BLUE BIRD

SUBJECT: SERVICE BULLETIN S10SS STARTER CABLE BOOT REPLACEMENT

MODELS AFFECTED: 2011 MODEL YEAR ALL AMERICAN (A3FE/D3FE/D3RE) BUSES EQUIPPED WITH CUMMINS ISB10 ENGINES

Starter Cable Boot Replacement

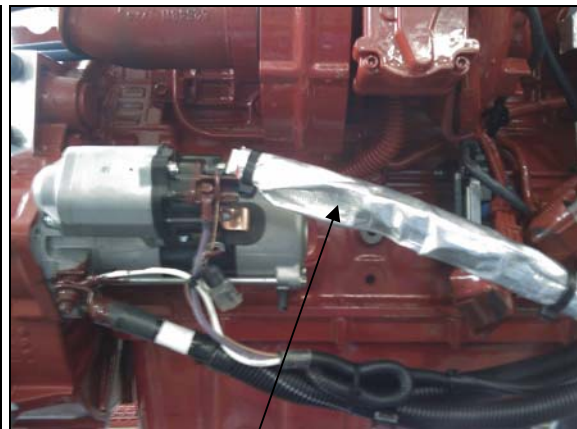
Positive starter cable boot may deform due to heat from engine turbo.

2. Disconnect all negative (black) battery cables first, then all positive (red) battery cables from the batteries.
3. Remove the starter cable (red) from the starter using 11/16" wrench or socket, then remove red rubber boot or silver heat shield from cable.

Red Rubber Boot

Silver Heat Shield

Replace original starter cable boot with new insulated sleeve over starter cable end.
